# new delay configuration

.....  
This is a proposal for a new delay configuration on the fs table.

Figure 2: new

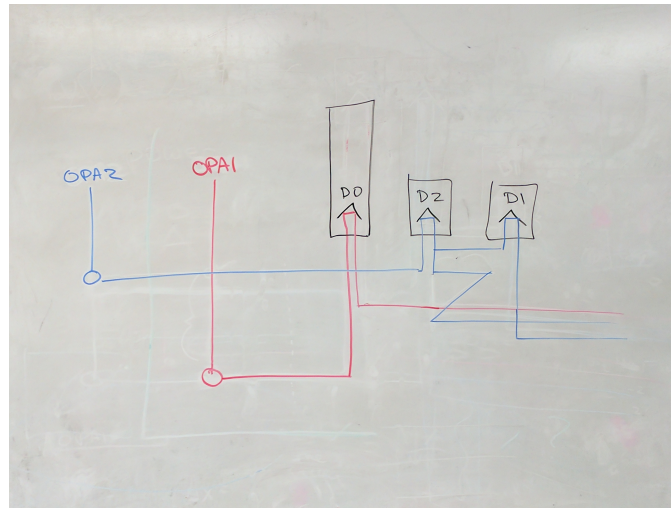
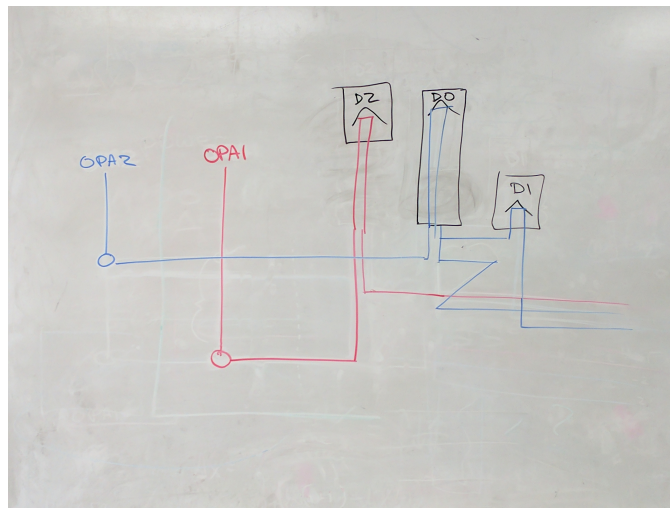
I propose that the ideal delay configuration would place the long-travel stage on the pump beamline for all experiments. Currently, the long-travel stage is on OPA1. In this configuration we are asked to either change the role of OPAs (pump with OPA1) or scan the probe delay. I'd like to keep the role of the OPAs consistent to make comparison between TREE and self-heterodyned experiments easier.

Since we currently have at-most three beams impingement upon the sample, our three delays *over-constrain* the delay space. Indeed, d2 and d0 both modify the same logical delay ( $\tau_{21}$ ). **I propose that we switch the locations of the stages.**

Note that, because d0 is now controlling our *pump* line, we want the majority of our dynamic range to be towards *shorter* path lengths. This means that zero delay will place d0 in the 'far' configuration, somewhat annoyingly. d2 will also be 'far', but it can be brought a couple inches closer by adjusting the OPA2 beamline one inch inward and OPA1 one inch outward.

This change will add about 10 inches to our path length. This change will be inconsequential for our focusing setup.

This change will make it less convenient to do multi-pass experiments in the long travel stage, but multi-pass is still possible.

In pump-probe geometry, the transmitted split-pump will be blocked (or the beam splitter will be replaced by a mirror).

There should be no need to introduce/remove the OPA2 dogleg in this configuration.
